Re: Bayshore Pines RPD
DCI2022-00048

Below is our response to the letter of review dated Oct. 19, 2022. We are addressing each comment below for clarification.

BAYSHORE PINES RPD
BIG LLC
MASTER CONCEPT PLAN

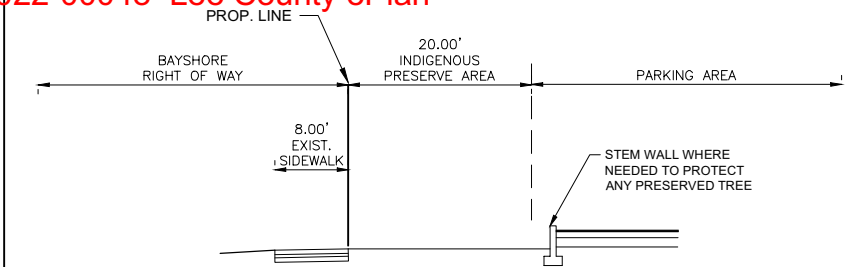
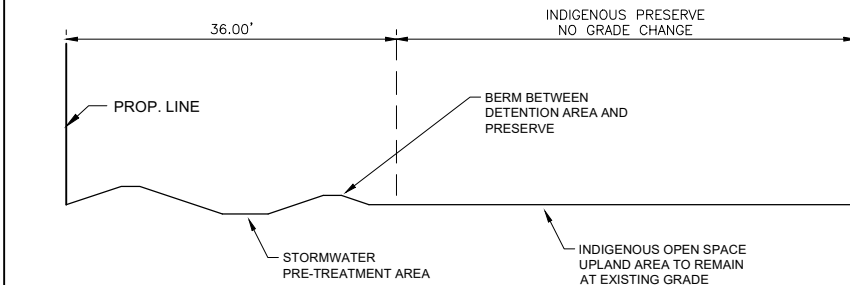
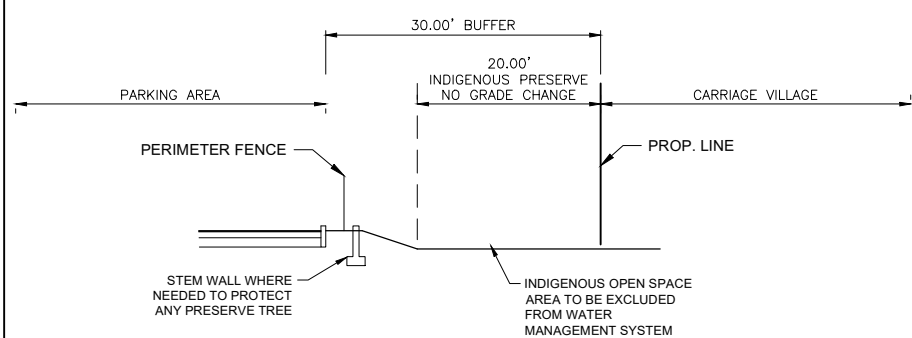
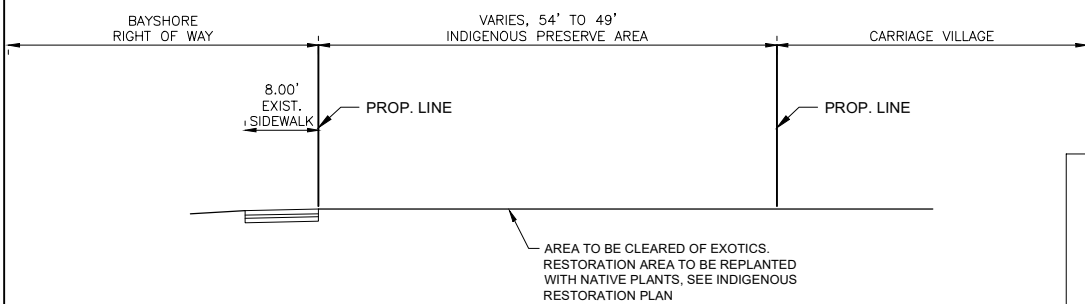
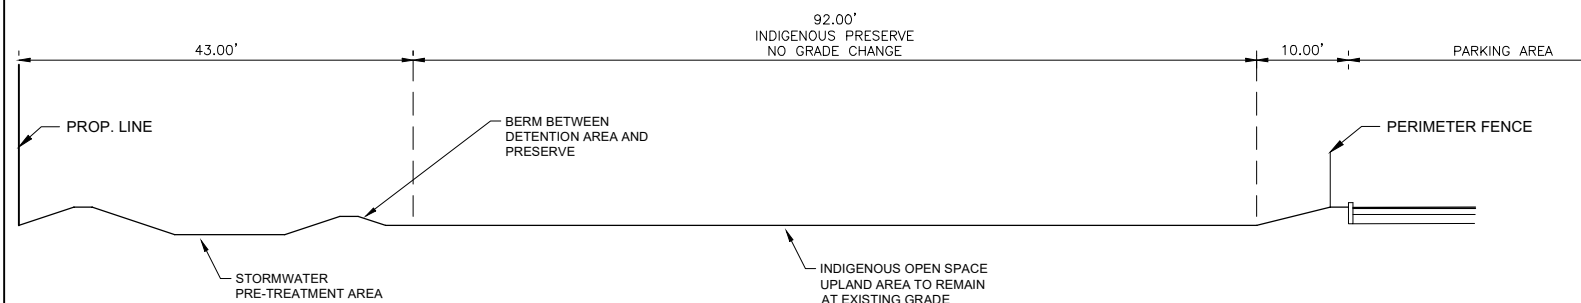
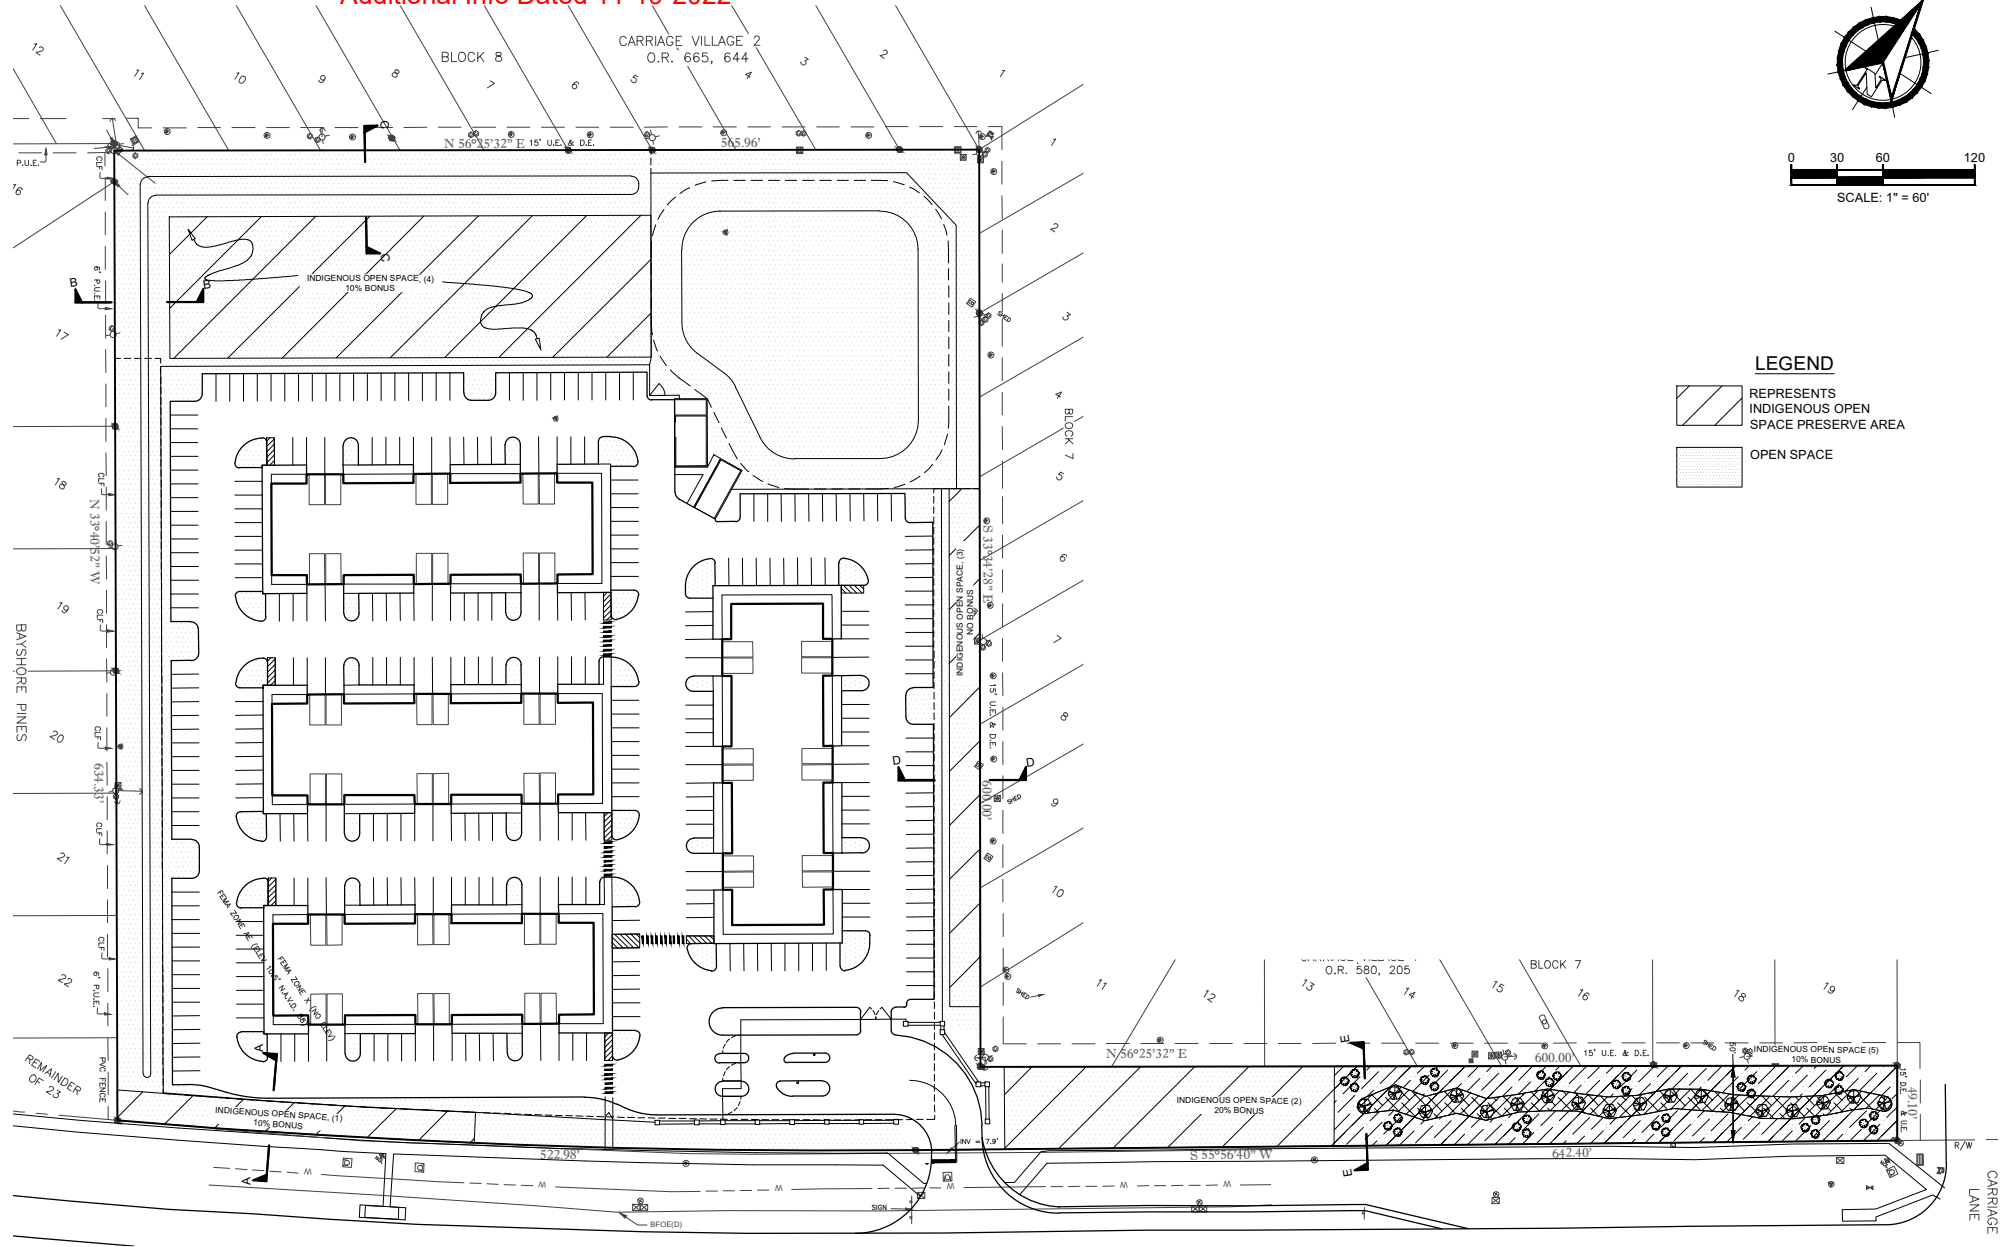
The applicant is depicting along the southeast property line on the MCP the preserve to serve as the buffer. Please provide cross sections depicting how the slash pines and oak roots will be protected during the development of the parking area. Indicate if a berm and or drainage features will be constructed and how the indigenous trees within the preserve limits will be protected per the LDC. The indigenous management plan must include information as well as the surface water management plan.

We have added a plan sheet for the indigenous preserve areas along with conceptual cross sections of each area. This area will remain outside of the storm water management area and retaining walls will be installed at necessary to protect this area from the fill material that will be required for the adjacent parking area. This will allow the existing trees to be better preserved as much as possible. The exact details and tree locations will be determined during the DO process.

BAYSHORE PINES RPD
BIG LLC
OPEN SPACE PLAN

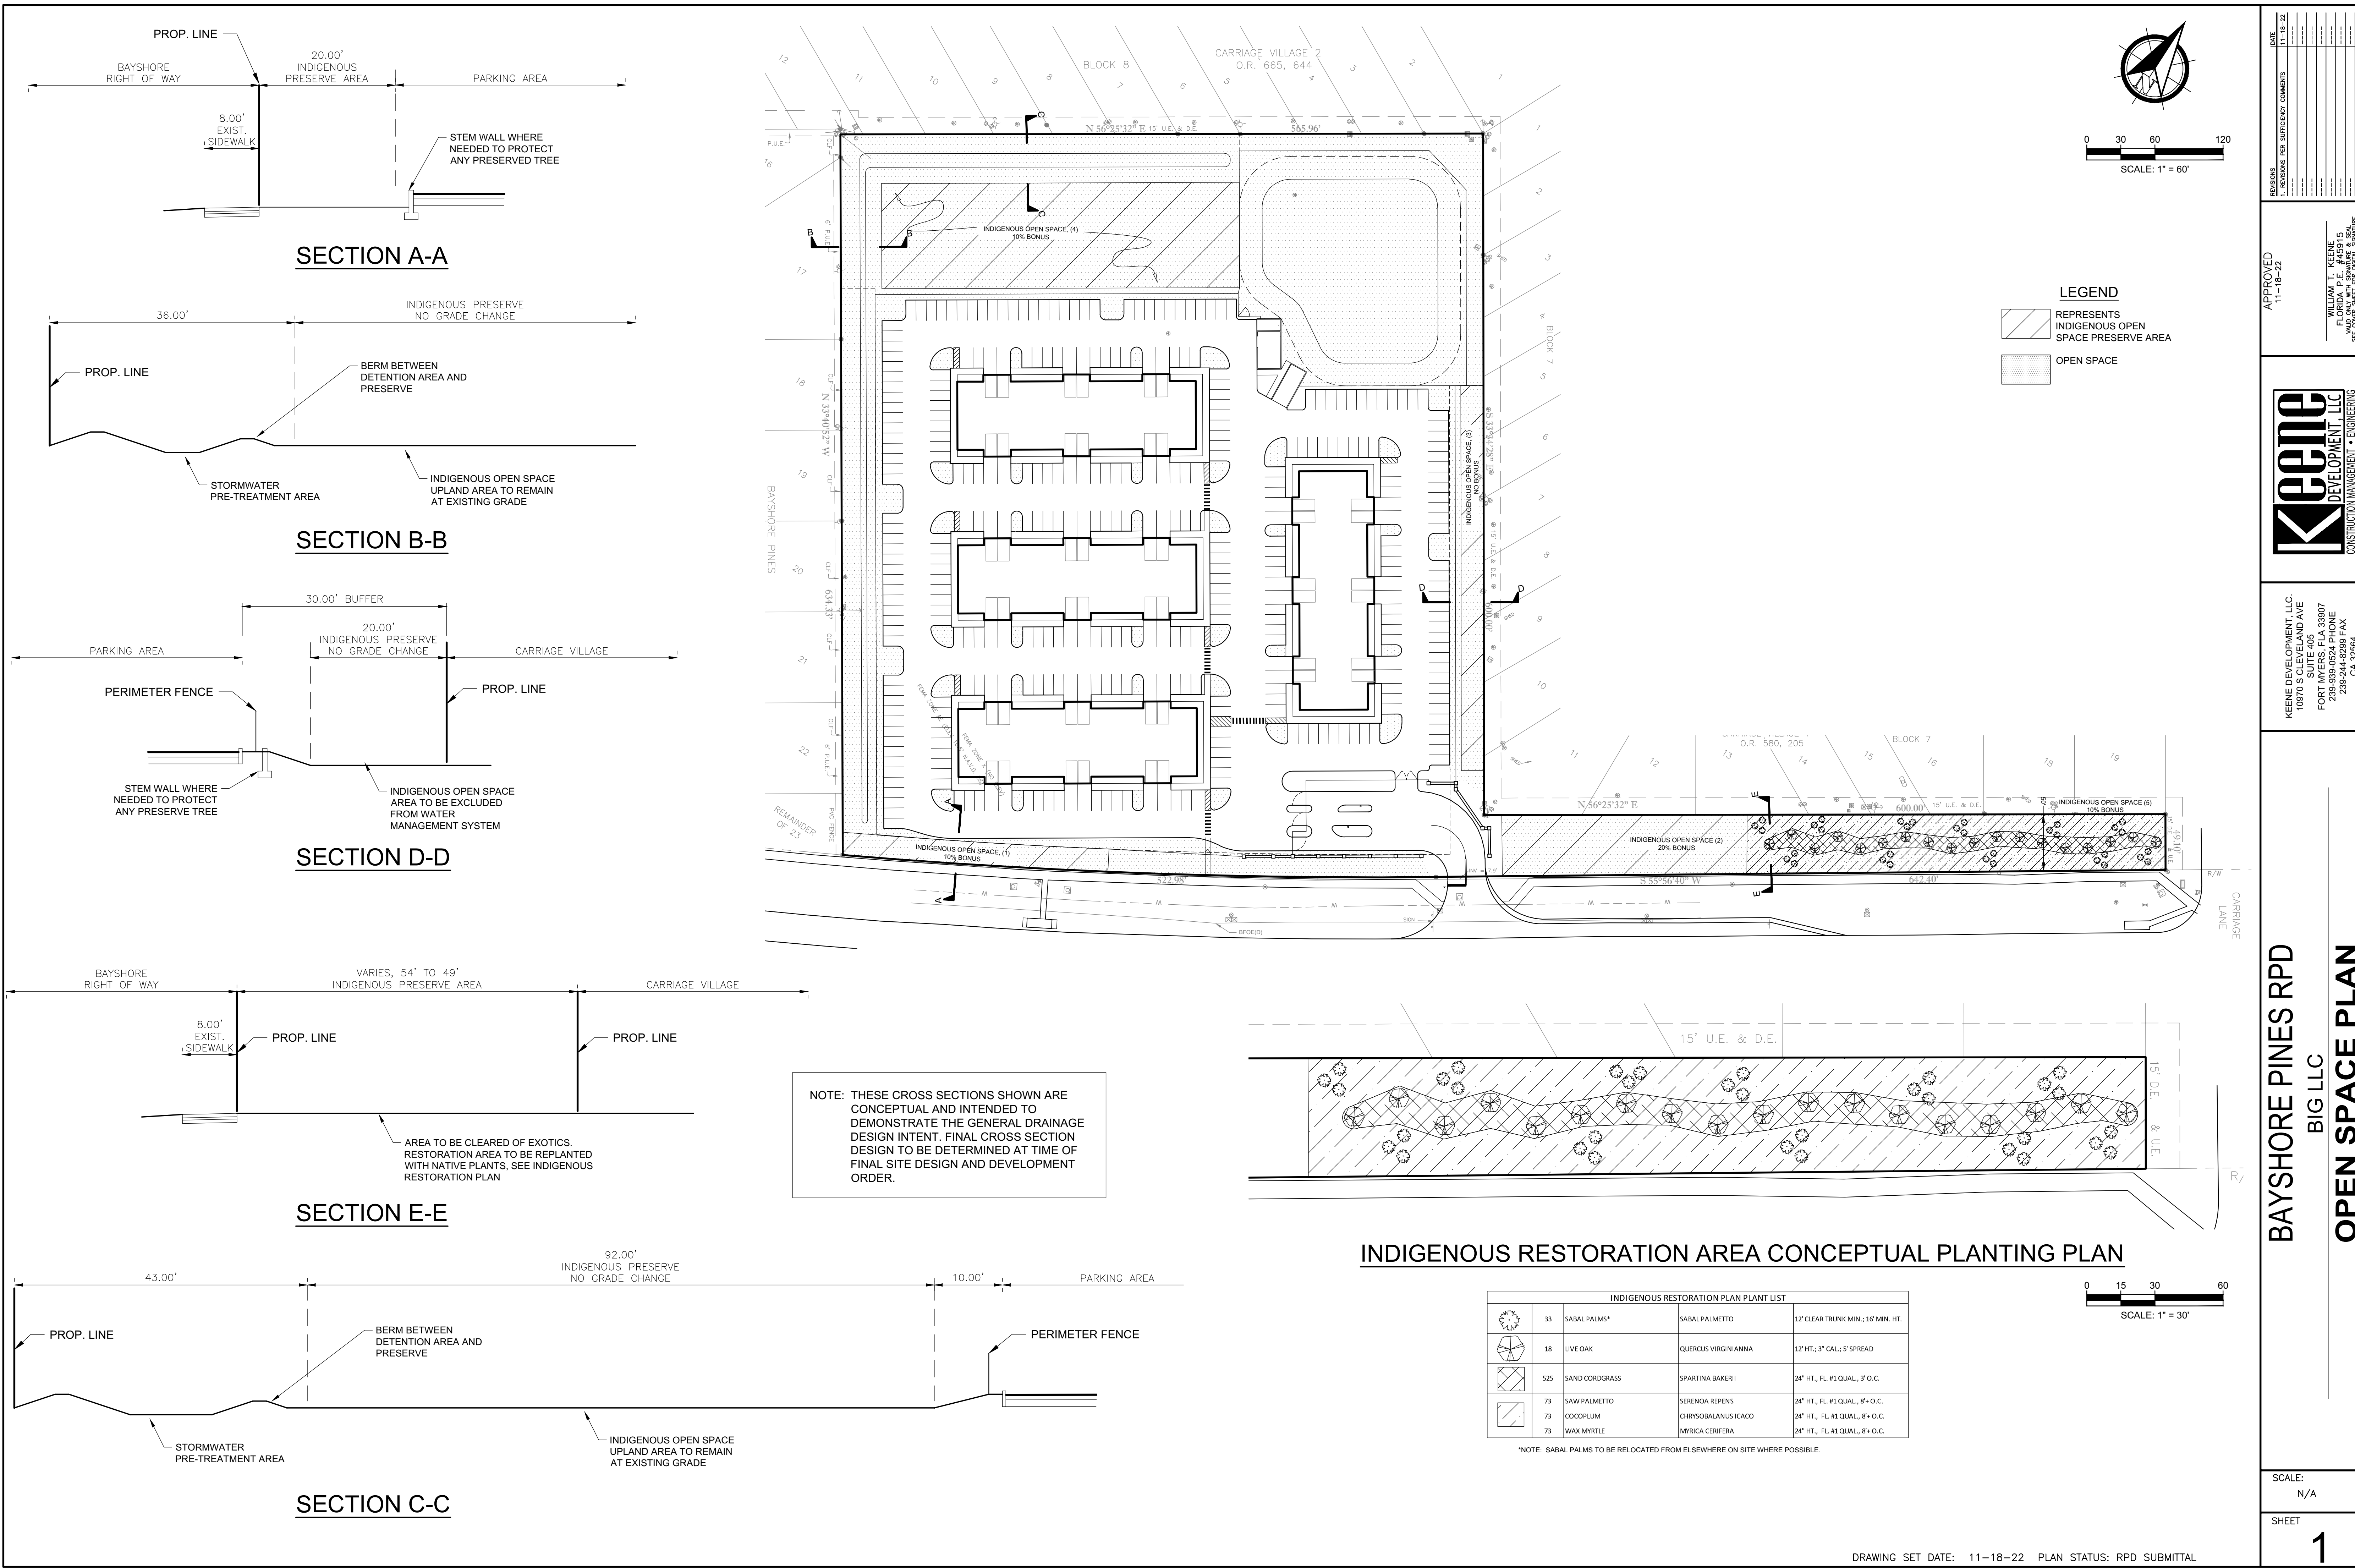
Provide an indigenous management plan.

See included indigenous management plan. There is one are of the site we are proposing to restore. This will have a secondary benefit of improving the buffer between Bayshore Road and Carriage Village as we remove the existing exotic vegetation in that area.
